UNITED STATES PATENT AND TRADEMARK OFFICE

APPLICATION NO.	FILING DATE	FIRST NAMED INVENTOR	ATTORNEY DOCKET NO.	CONFIRMATION NO.
10/670,045	09/24/2003	James R. Hawkinson	165.001US01	5025

Office Action Summary

DETAILED ACTION

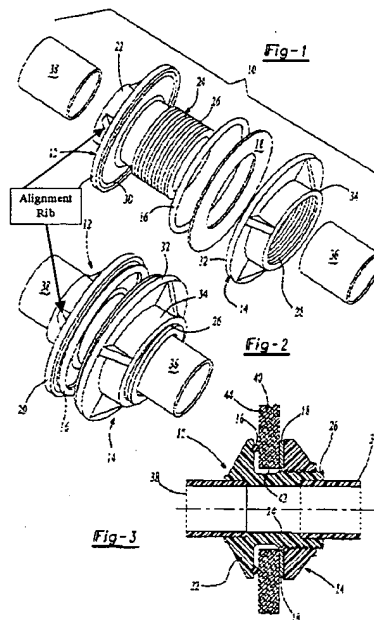
In regards to claim 1, Hawkins discloses a tank fitting comprising:
a coupling (12) comprising:

a flange (20) disposed between a first end and a second end of the coupling;

external threads (26) disposed between the flange and the first end; and

a male-end region (22) adjacent the second end adapted (capable of) to be received within a fitting or a pipe for bonding thereto;

a gasket (16, 18) disposed on the coupling between the flange and the first end of the coupling so as to abut the flange; and

a nut (14) threadably attachable to the external threads of the coupling.

In regards to claim 9, Hawkins discloses an alignment rib (see Figures 1 and 2 below) disposed on the coupling between the flange and the second end.

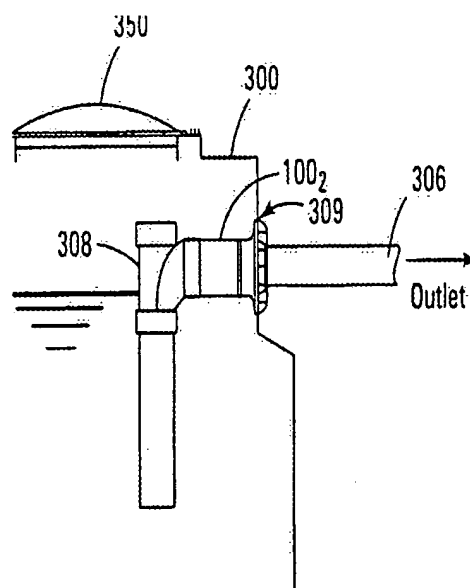
Applicant's arguments filed 1/26/2005 have been fully considered but they are not persuasive. The Applicant argues that Hawkins '444 does not disclose the male-end region adapted to be received within a fitting or a pipe for bonding thereto. The Examiner disagrees. The Applicant's Figure 3 below illustrates the male-end region adapted to be received within a fitting or a pipe for bonding thereto, in the same manner that Hawkins '444 discloses the male-end region adapted to be received within a fitting or a pipe for bonding thereto. The only difference between the Applicant's male-end and Hawkins '444 male-end is their respective lengths. Therefore, Hawkins '444 meets the claim limitation.
